E8363CH85-02A

S E R V I C E N O T E

E8363CH85 PNA Microwave Network Analyzers

A new touchscreen display inverter shield is available to improve PNA noise floor performance.

Figure 3

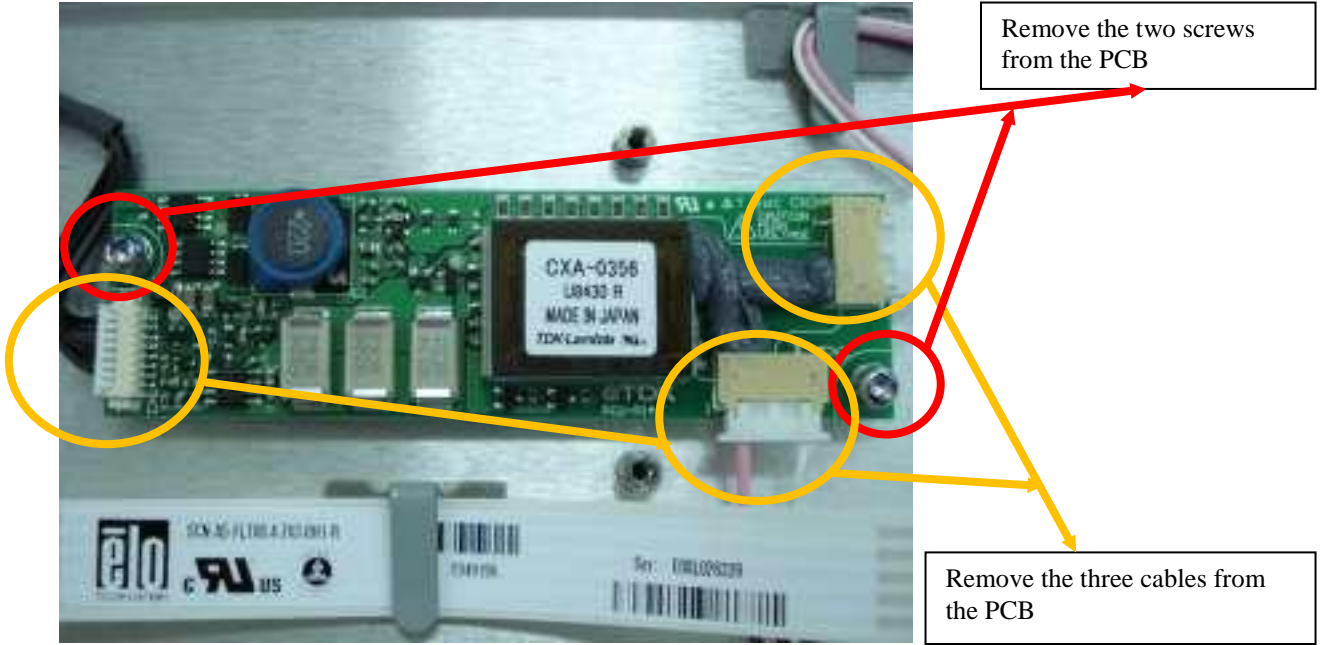
10. Remove the two screws from the PCB shown in Figure 3, using a T-10 wrench. Disconnect the three cables connected to the PCB.
